Access Compliance Report

Public Rights-of-Way

(Curb Ramps)

Intersection ID: 53147	Main Street: ACHIEVEMENT_LN	Cross Street: NEW_RENAISSANCE_WY	Location: SW
ADA ID: 575179630DC3	Ramp Type: Directional1	Initial Pass/Fail: Fail	Overall Compliance: No
Severity Score: 12.5			
Codes/Mitigation Info/Possible Solution		Field Measurements/Component Compliance

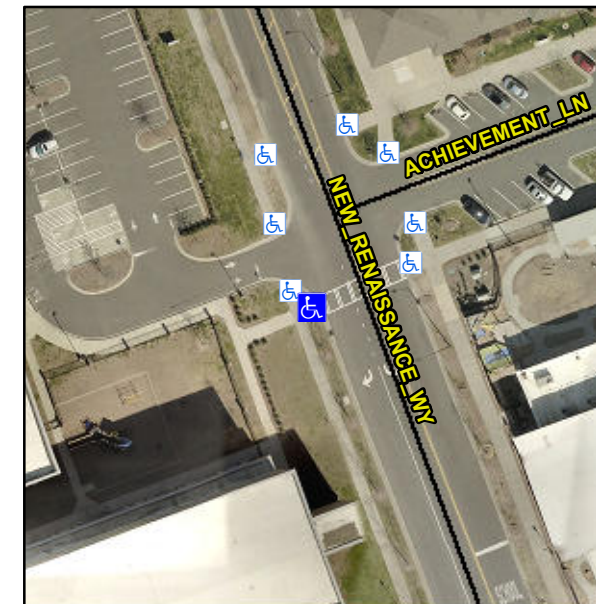
Compliance	Description	Data	Compliance	Description	Data
N/A	Ramp Length (in)	66.0	N/A	Grade Break?	N/A
Yes	Ramp Width (in)	70.0	N/A	Grade Break Slope (%)	0.0
Yes	Ramp Slope (%)	7.5	N/A	Grade Break XSlope (%)	0.0
No	Ramp XSlope (%)	6.2			
N/A	Flare Type LT	N/A	N/A	Flare Type RT	N/A
N/A	Flare Slope LT (%)	N/A	N/A	Flare Slope RT (%)	0.0
N/A	Flare Traversable LT?	N/A	N/A	Flare Traversable RT?	N/A
N/A	Landing Length (in)	0.0	N/A	DWS Provided?	N/A
N/A	Landing Width (in)	0.0	N/A	DWS Contrast?	N/A
N/A	Landing Slope (%)	0.0	N/A	DWS Length (in)	N/A
N/A	Landing X Slope (%)	0.0	N/A	DWS Full Width?	N/A
N/A	Landing Curb? (Y/N)	N/A	N/A	DWS Offset LT (in)	N/A
N/A	Shared Landing?	N/A	N/A	DWS Offset RT (in)	N/A
N/A	Gutter Ponding?	0.0	N/A	Gutter Slope (%)	N/A
N/A	Gutter Lip Ht (in)	0.0	N/A	Gutter X Slope (%)	N/A
N/A	Painted X Walk1?	No		Road Slope (%)	2.9
	X Walk 1 Direction	To NE		Road X Slope (%)	0.4
	X Walk 1 Width (in)	N/A		Clear Space?	N/A

Remove & Replace Entire Ramp.

R304.5.3
